V-48  
(2017)

**PETITION No.:** V-48

**PROPERTY LOCATION:** On the north side of Upland Drive, west of Upland Court (3775 Upland Drive).

**TYPE OF VARIANCE:** Waive the rear setback from the required 40 feet to 25 feet.

LOT 314  
BLOCK  
UNIT 1  
SUB. HIGHLAND PARK

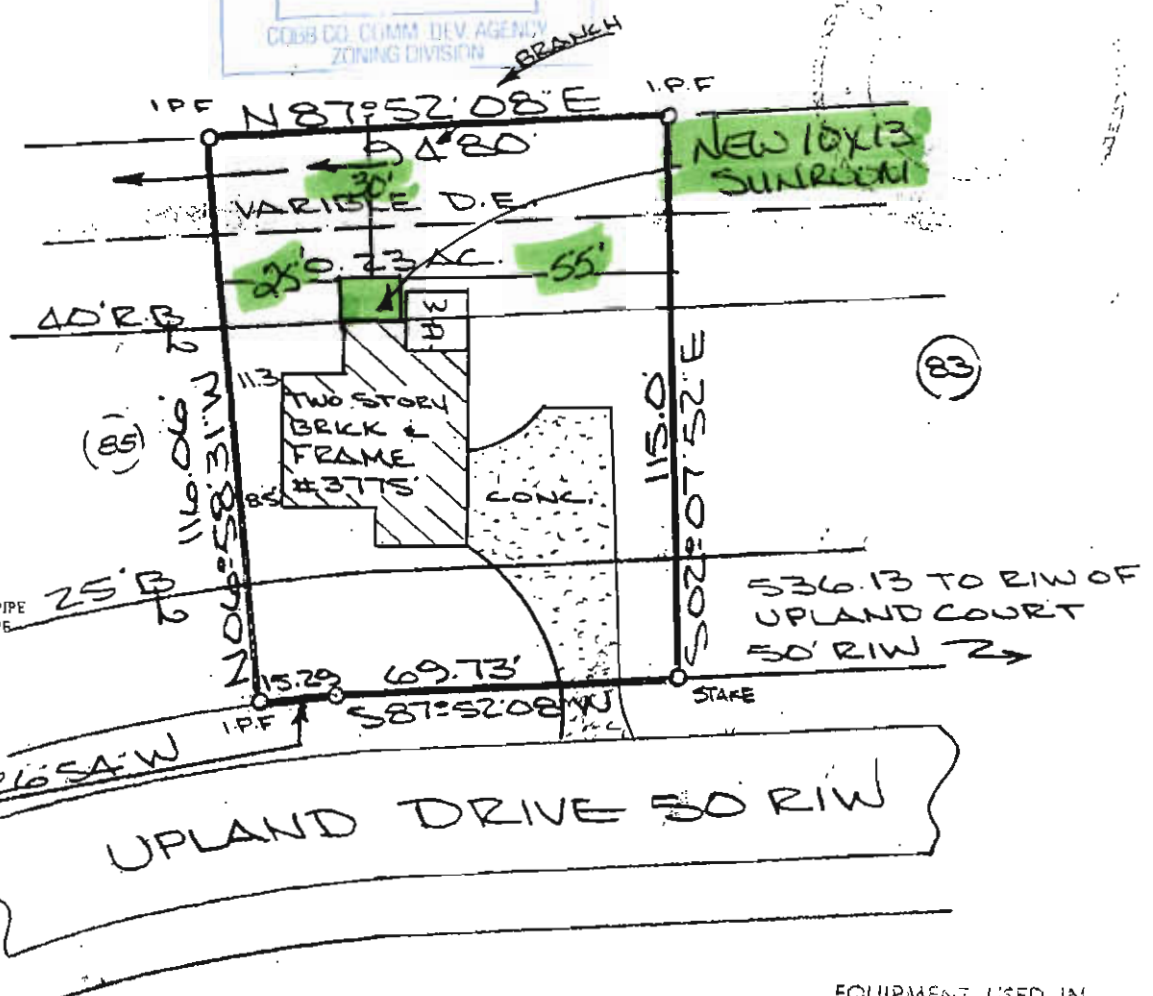
**SITE PLAN REVIEW:** If this variance request is approved, a subdivision plat revision must be recorded prior to the issuance of the certificate of occupancy showing all improvements on the lot along with any approved setback reductions, and referencing the variance case in the standard plat revision note. The surveyor must submit the plat to the Site Plan Review Section, Community Development Agency for review and approval prior to recording. Call 770-528-2147.

**STORMWATER MANAGEMENT:** The proposed addition is located outside the adjacent recorded drainage easement. However, the stream that traverses this parcel is identified as a buffered stream on the County's Stream Buffer Map and the addition is well within the undisturbed stream buffer and impervious setback. If this variance is approved it must be subject to obtaining a stream buffer variance.
